MONROE COUNTY DRAINAGE BOARD
Wednesday October 4, 2023, at 8:30 AM
Location: Showers Building Room 106D
Hybrid Meeting with Virtual Attendance via Zoom

Project Name: Highland Park Elementary
Engineer/Design Firm: Andy Knust, BRCJ
Address: W Gifford Rd.
Acres: 19.99 acre site, 1.64 ac disturb

Highland Park Elementary – Drainage Comments

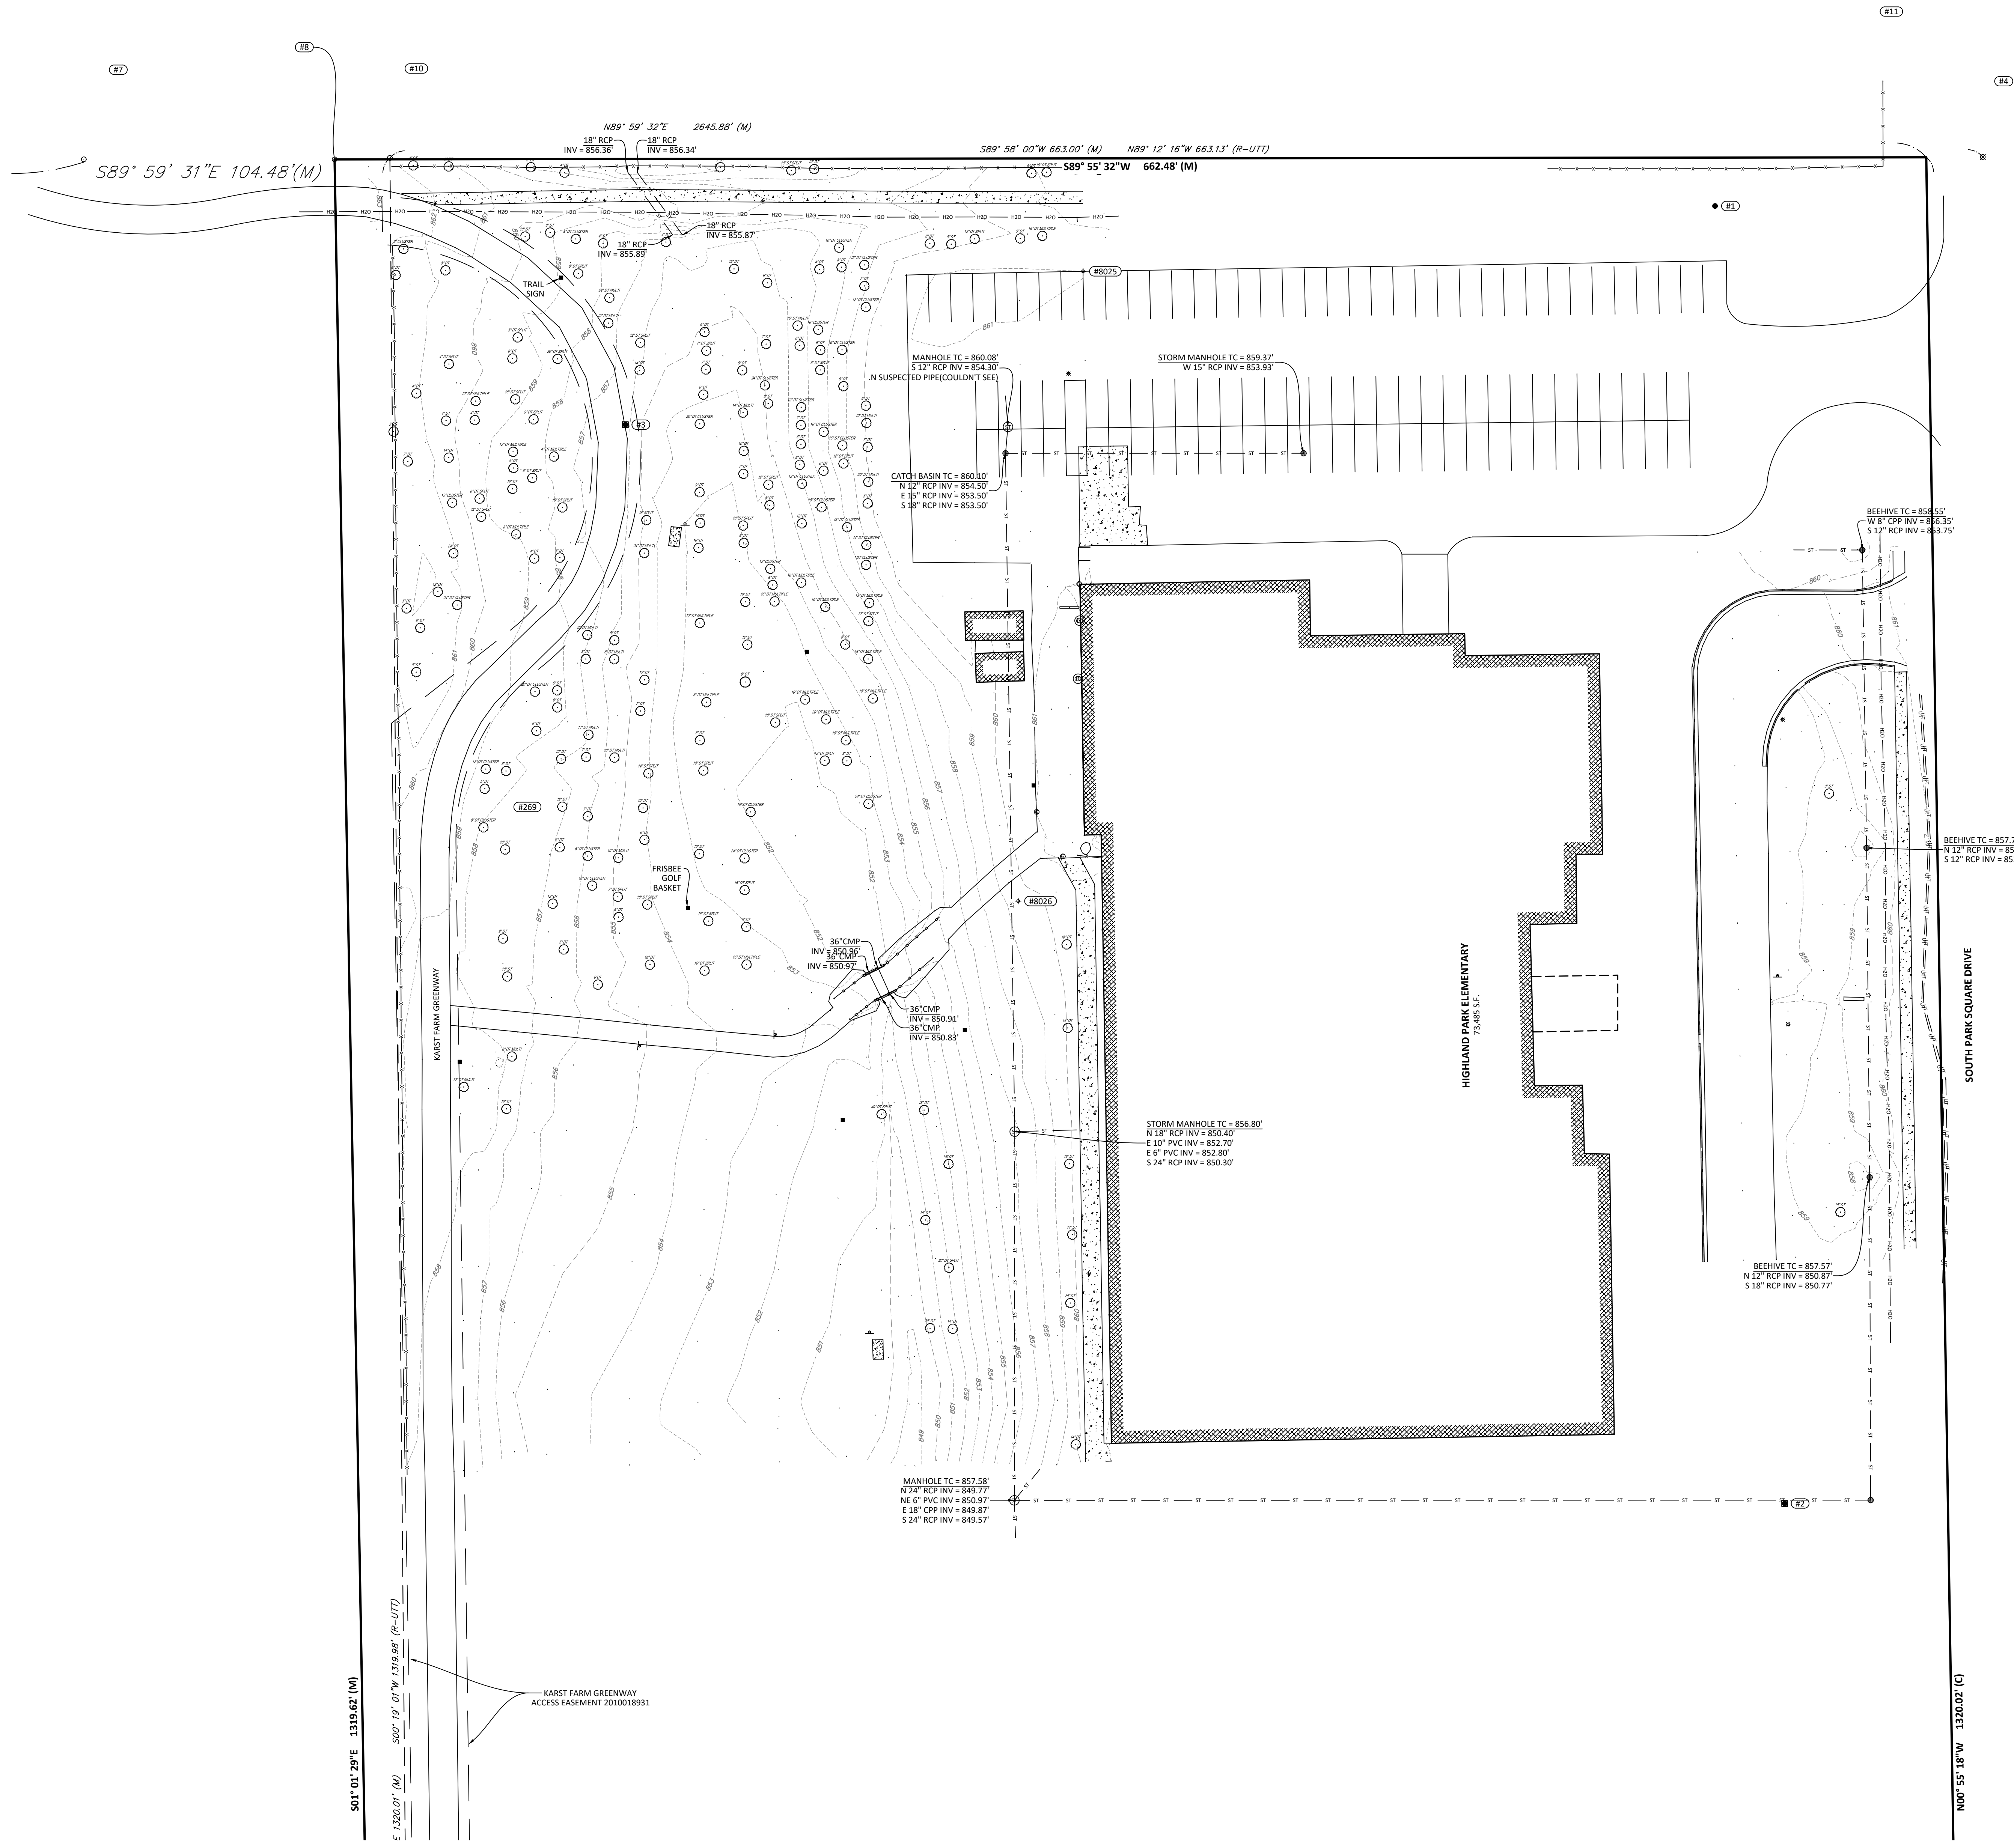
- This project is in the Sinking Creek critical watershed.

- Defined stream drains existing pond.
- Downstream drainage concerns at Bloomington Church of Christ and at 4595 W Gifford Rd.

- No additional water quality treatment measures are proposed, aside from the storage volume and vegetation in the modified detention pond.

- The stream and detention pond will be placed in a Drainage Easement.
